THIS BULLETIN DOES NOT CHANGE AIRCRAFT TYPE DESIGN

SUBJECT: Improve Headset Clarity in NXi Installed Aircraft

MODELS/ SN M20U Ovation Ultra - 32-0002
AFFECTED: M20V Acclaim Ultra - 33-0002, 33-0003, 33-0005

Figure SB M20-331-1 - GDL69A CAP AND STOW WIRE DIAGRAM

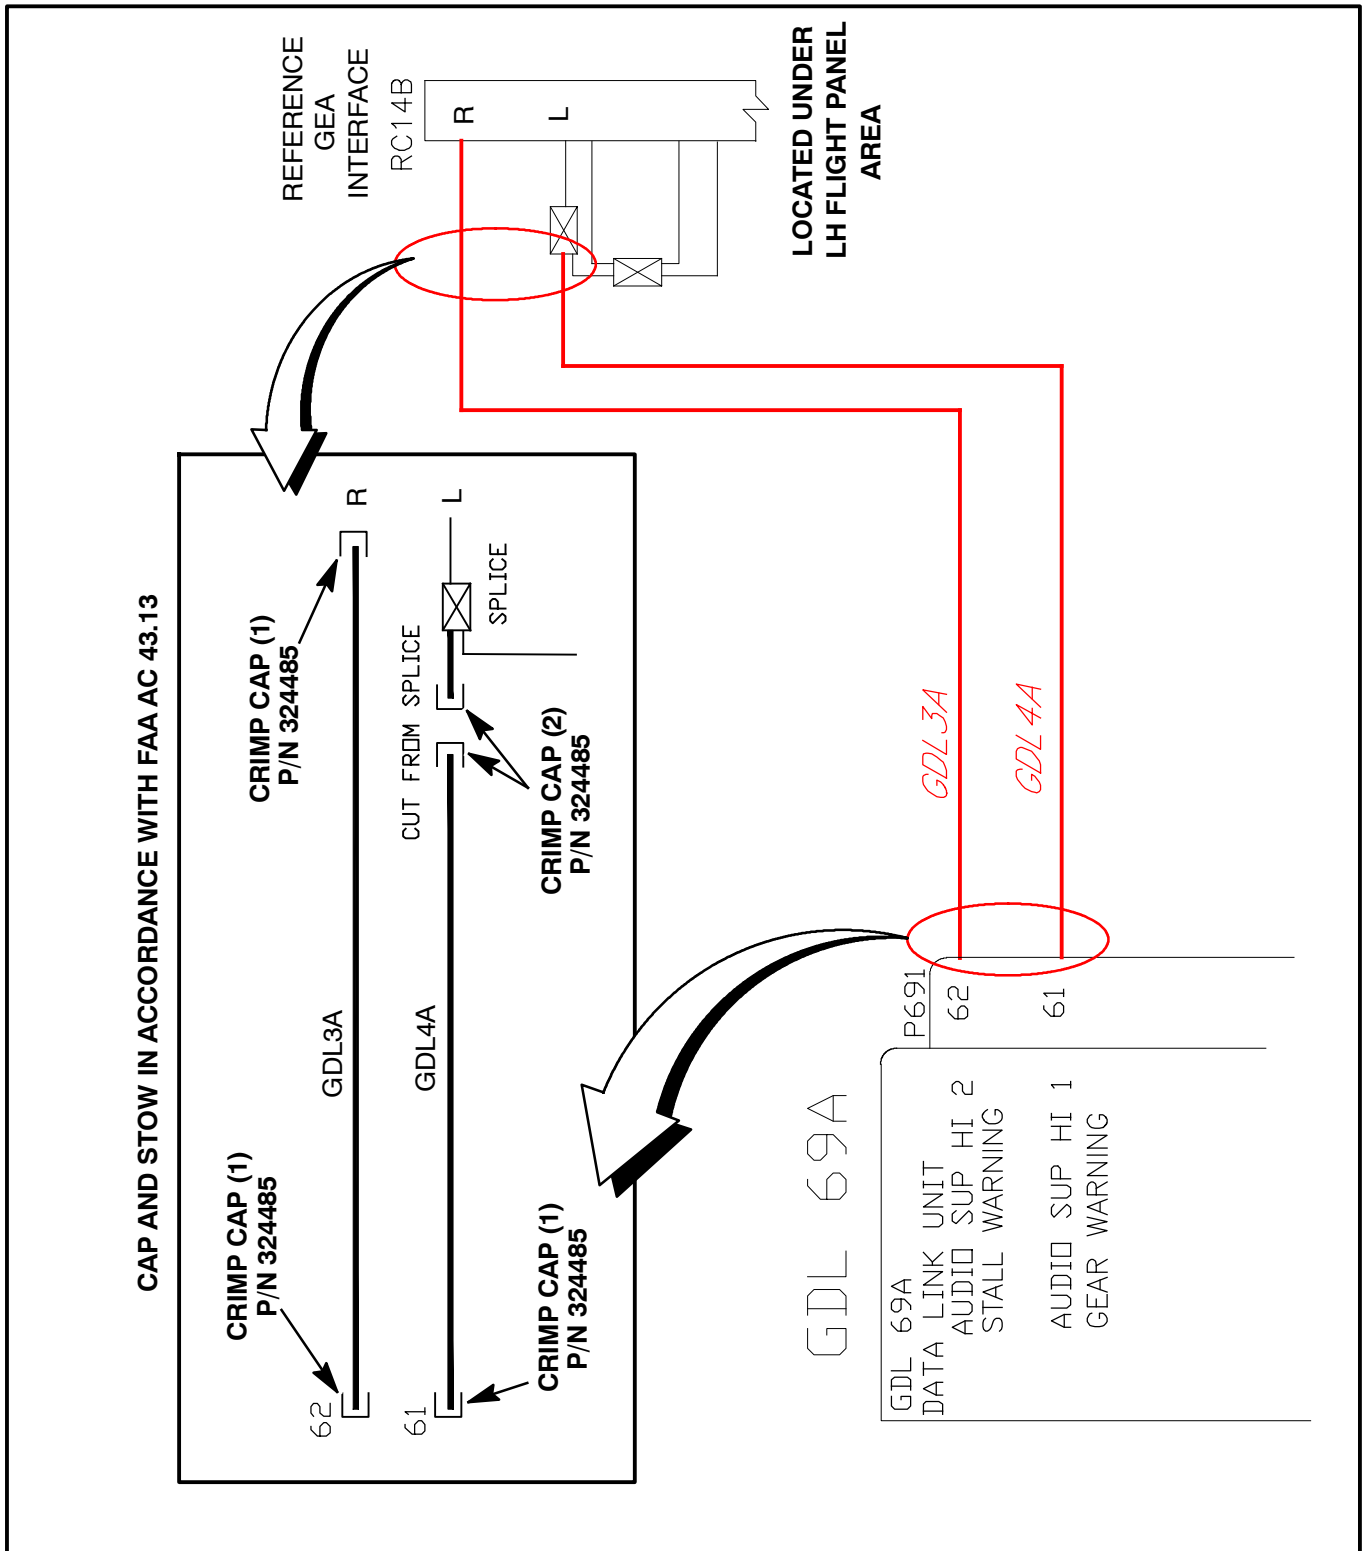
INTRODUCTION: It has been discovered in the field (one aircraft), when the stall vane is on the threshold of being activated, popping and crackling can be heard in the headsets on NXi installed Mooney M20U and M20V Ultra aircraft. Mooney Engineering concluded that 2 wires initially added into the configuration, were not required for new components of NXi Aircraft. This service bulletin provides instructions on disconnecting, capping and stowing the 2 extra wires. No safety issue is connected with this service bulletin.

- 1.4. Remove the connector P691 from the GDL back plate.
- 1.5. Locate wire GDL4A pin (#61) and remove from connector, refer to Figure M20-331-1.
- 1.6. Install crimp cap p/n 324485 and stow wire in accordance with FAA AC43.13, refer to Figure M20-331-1.

- 1.7. Locate wire GDL3A pin (#62) and remove from connector, refer to Figure M20-331-1.
- 1.8. Install crimp cap p/n 324485 and stow wire in accordance with FAA AC43.13, refer to Figure M20-331-1.

- 1.11. Locate wire GDL4A pin (#L), follow wire to wire splice, cut GDL4A wire allowing room to install crimp cap p/n 324485 to both cut ends, and stow wire in accordance with FAA AC43.13, refer to Figure M20-331-1.

- 1.12. Find wire GDL3A pin (#R) and remove from connector, refer to Figure M20-331-1.
- 1.13. Cut pin from wire, install crimp cap p/n 324485 and stow wire in accordance with FAA AC43.13, refer to Figure M20-331-1.
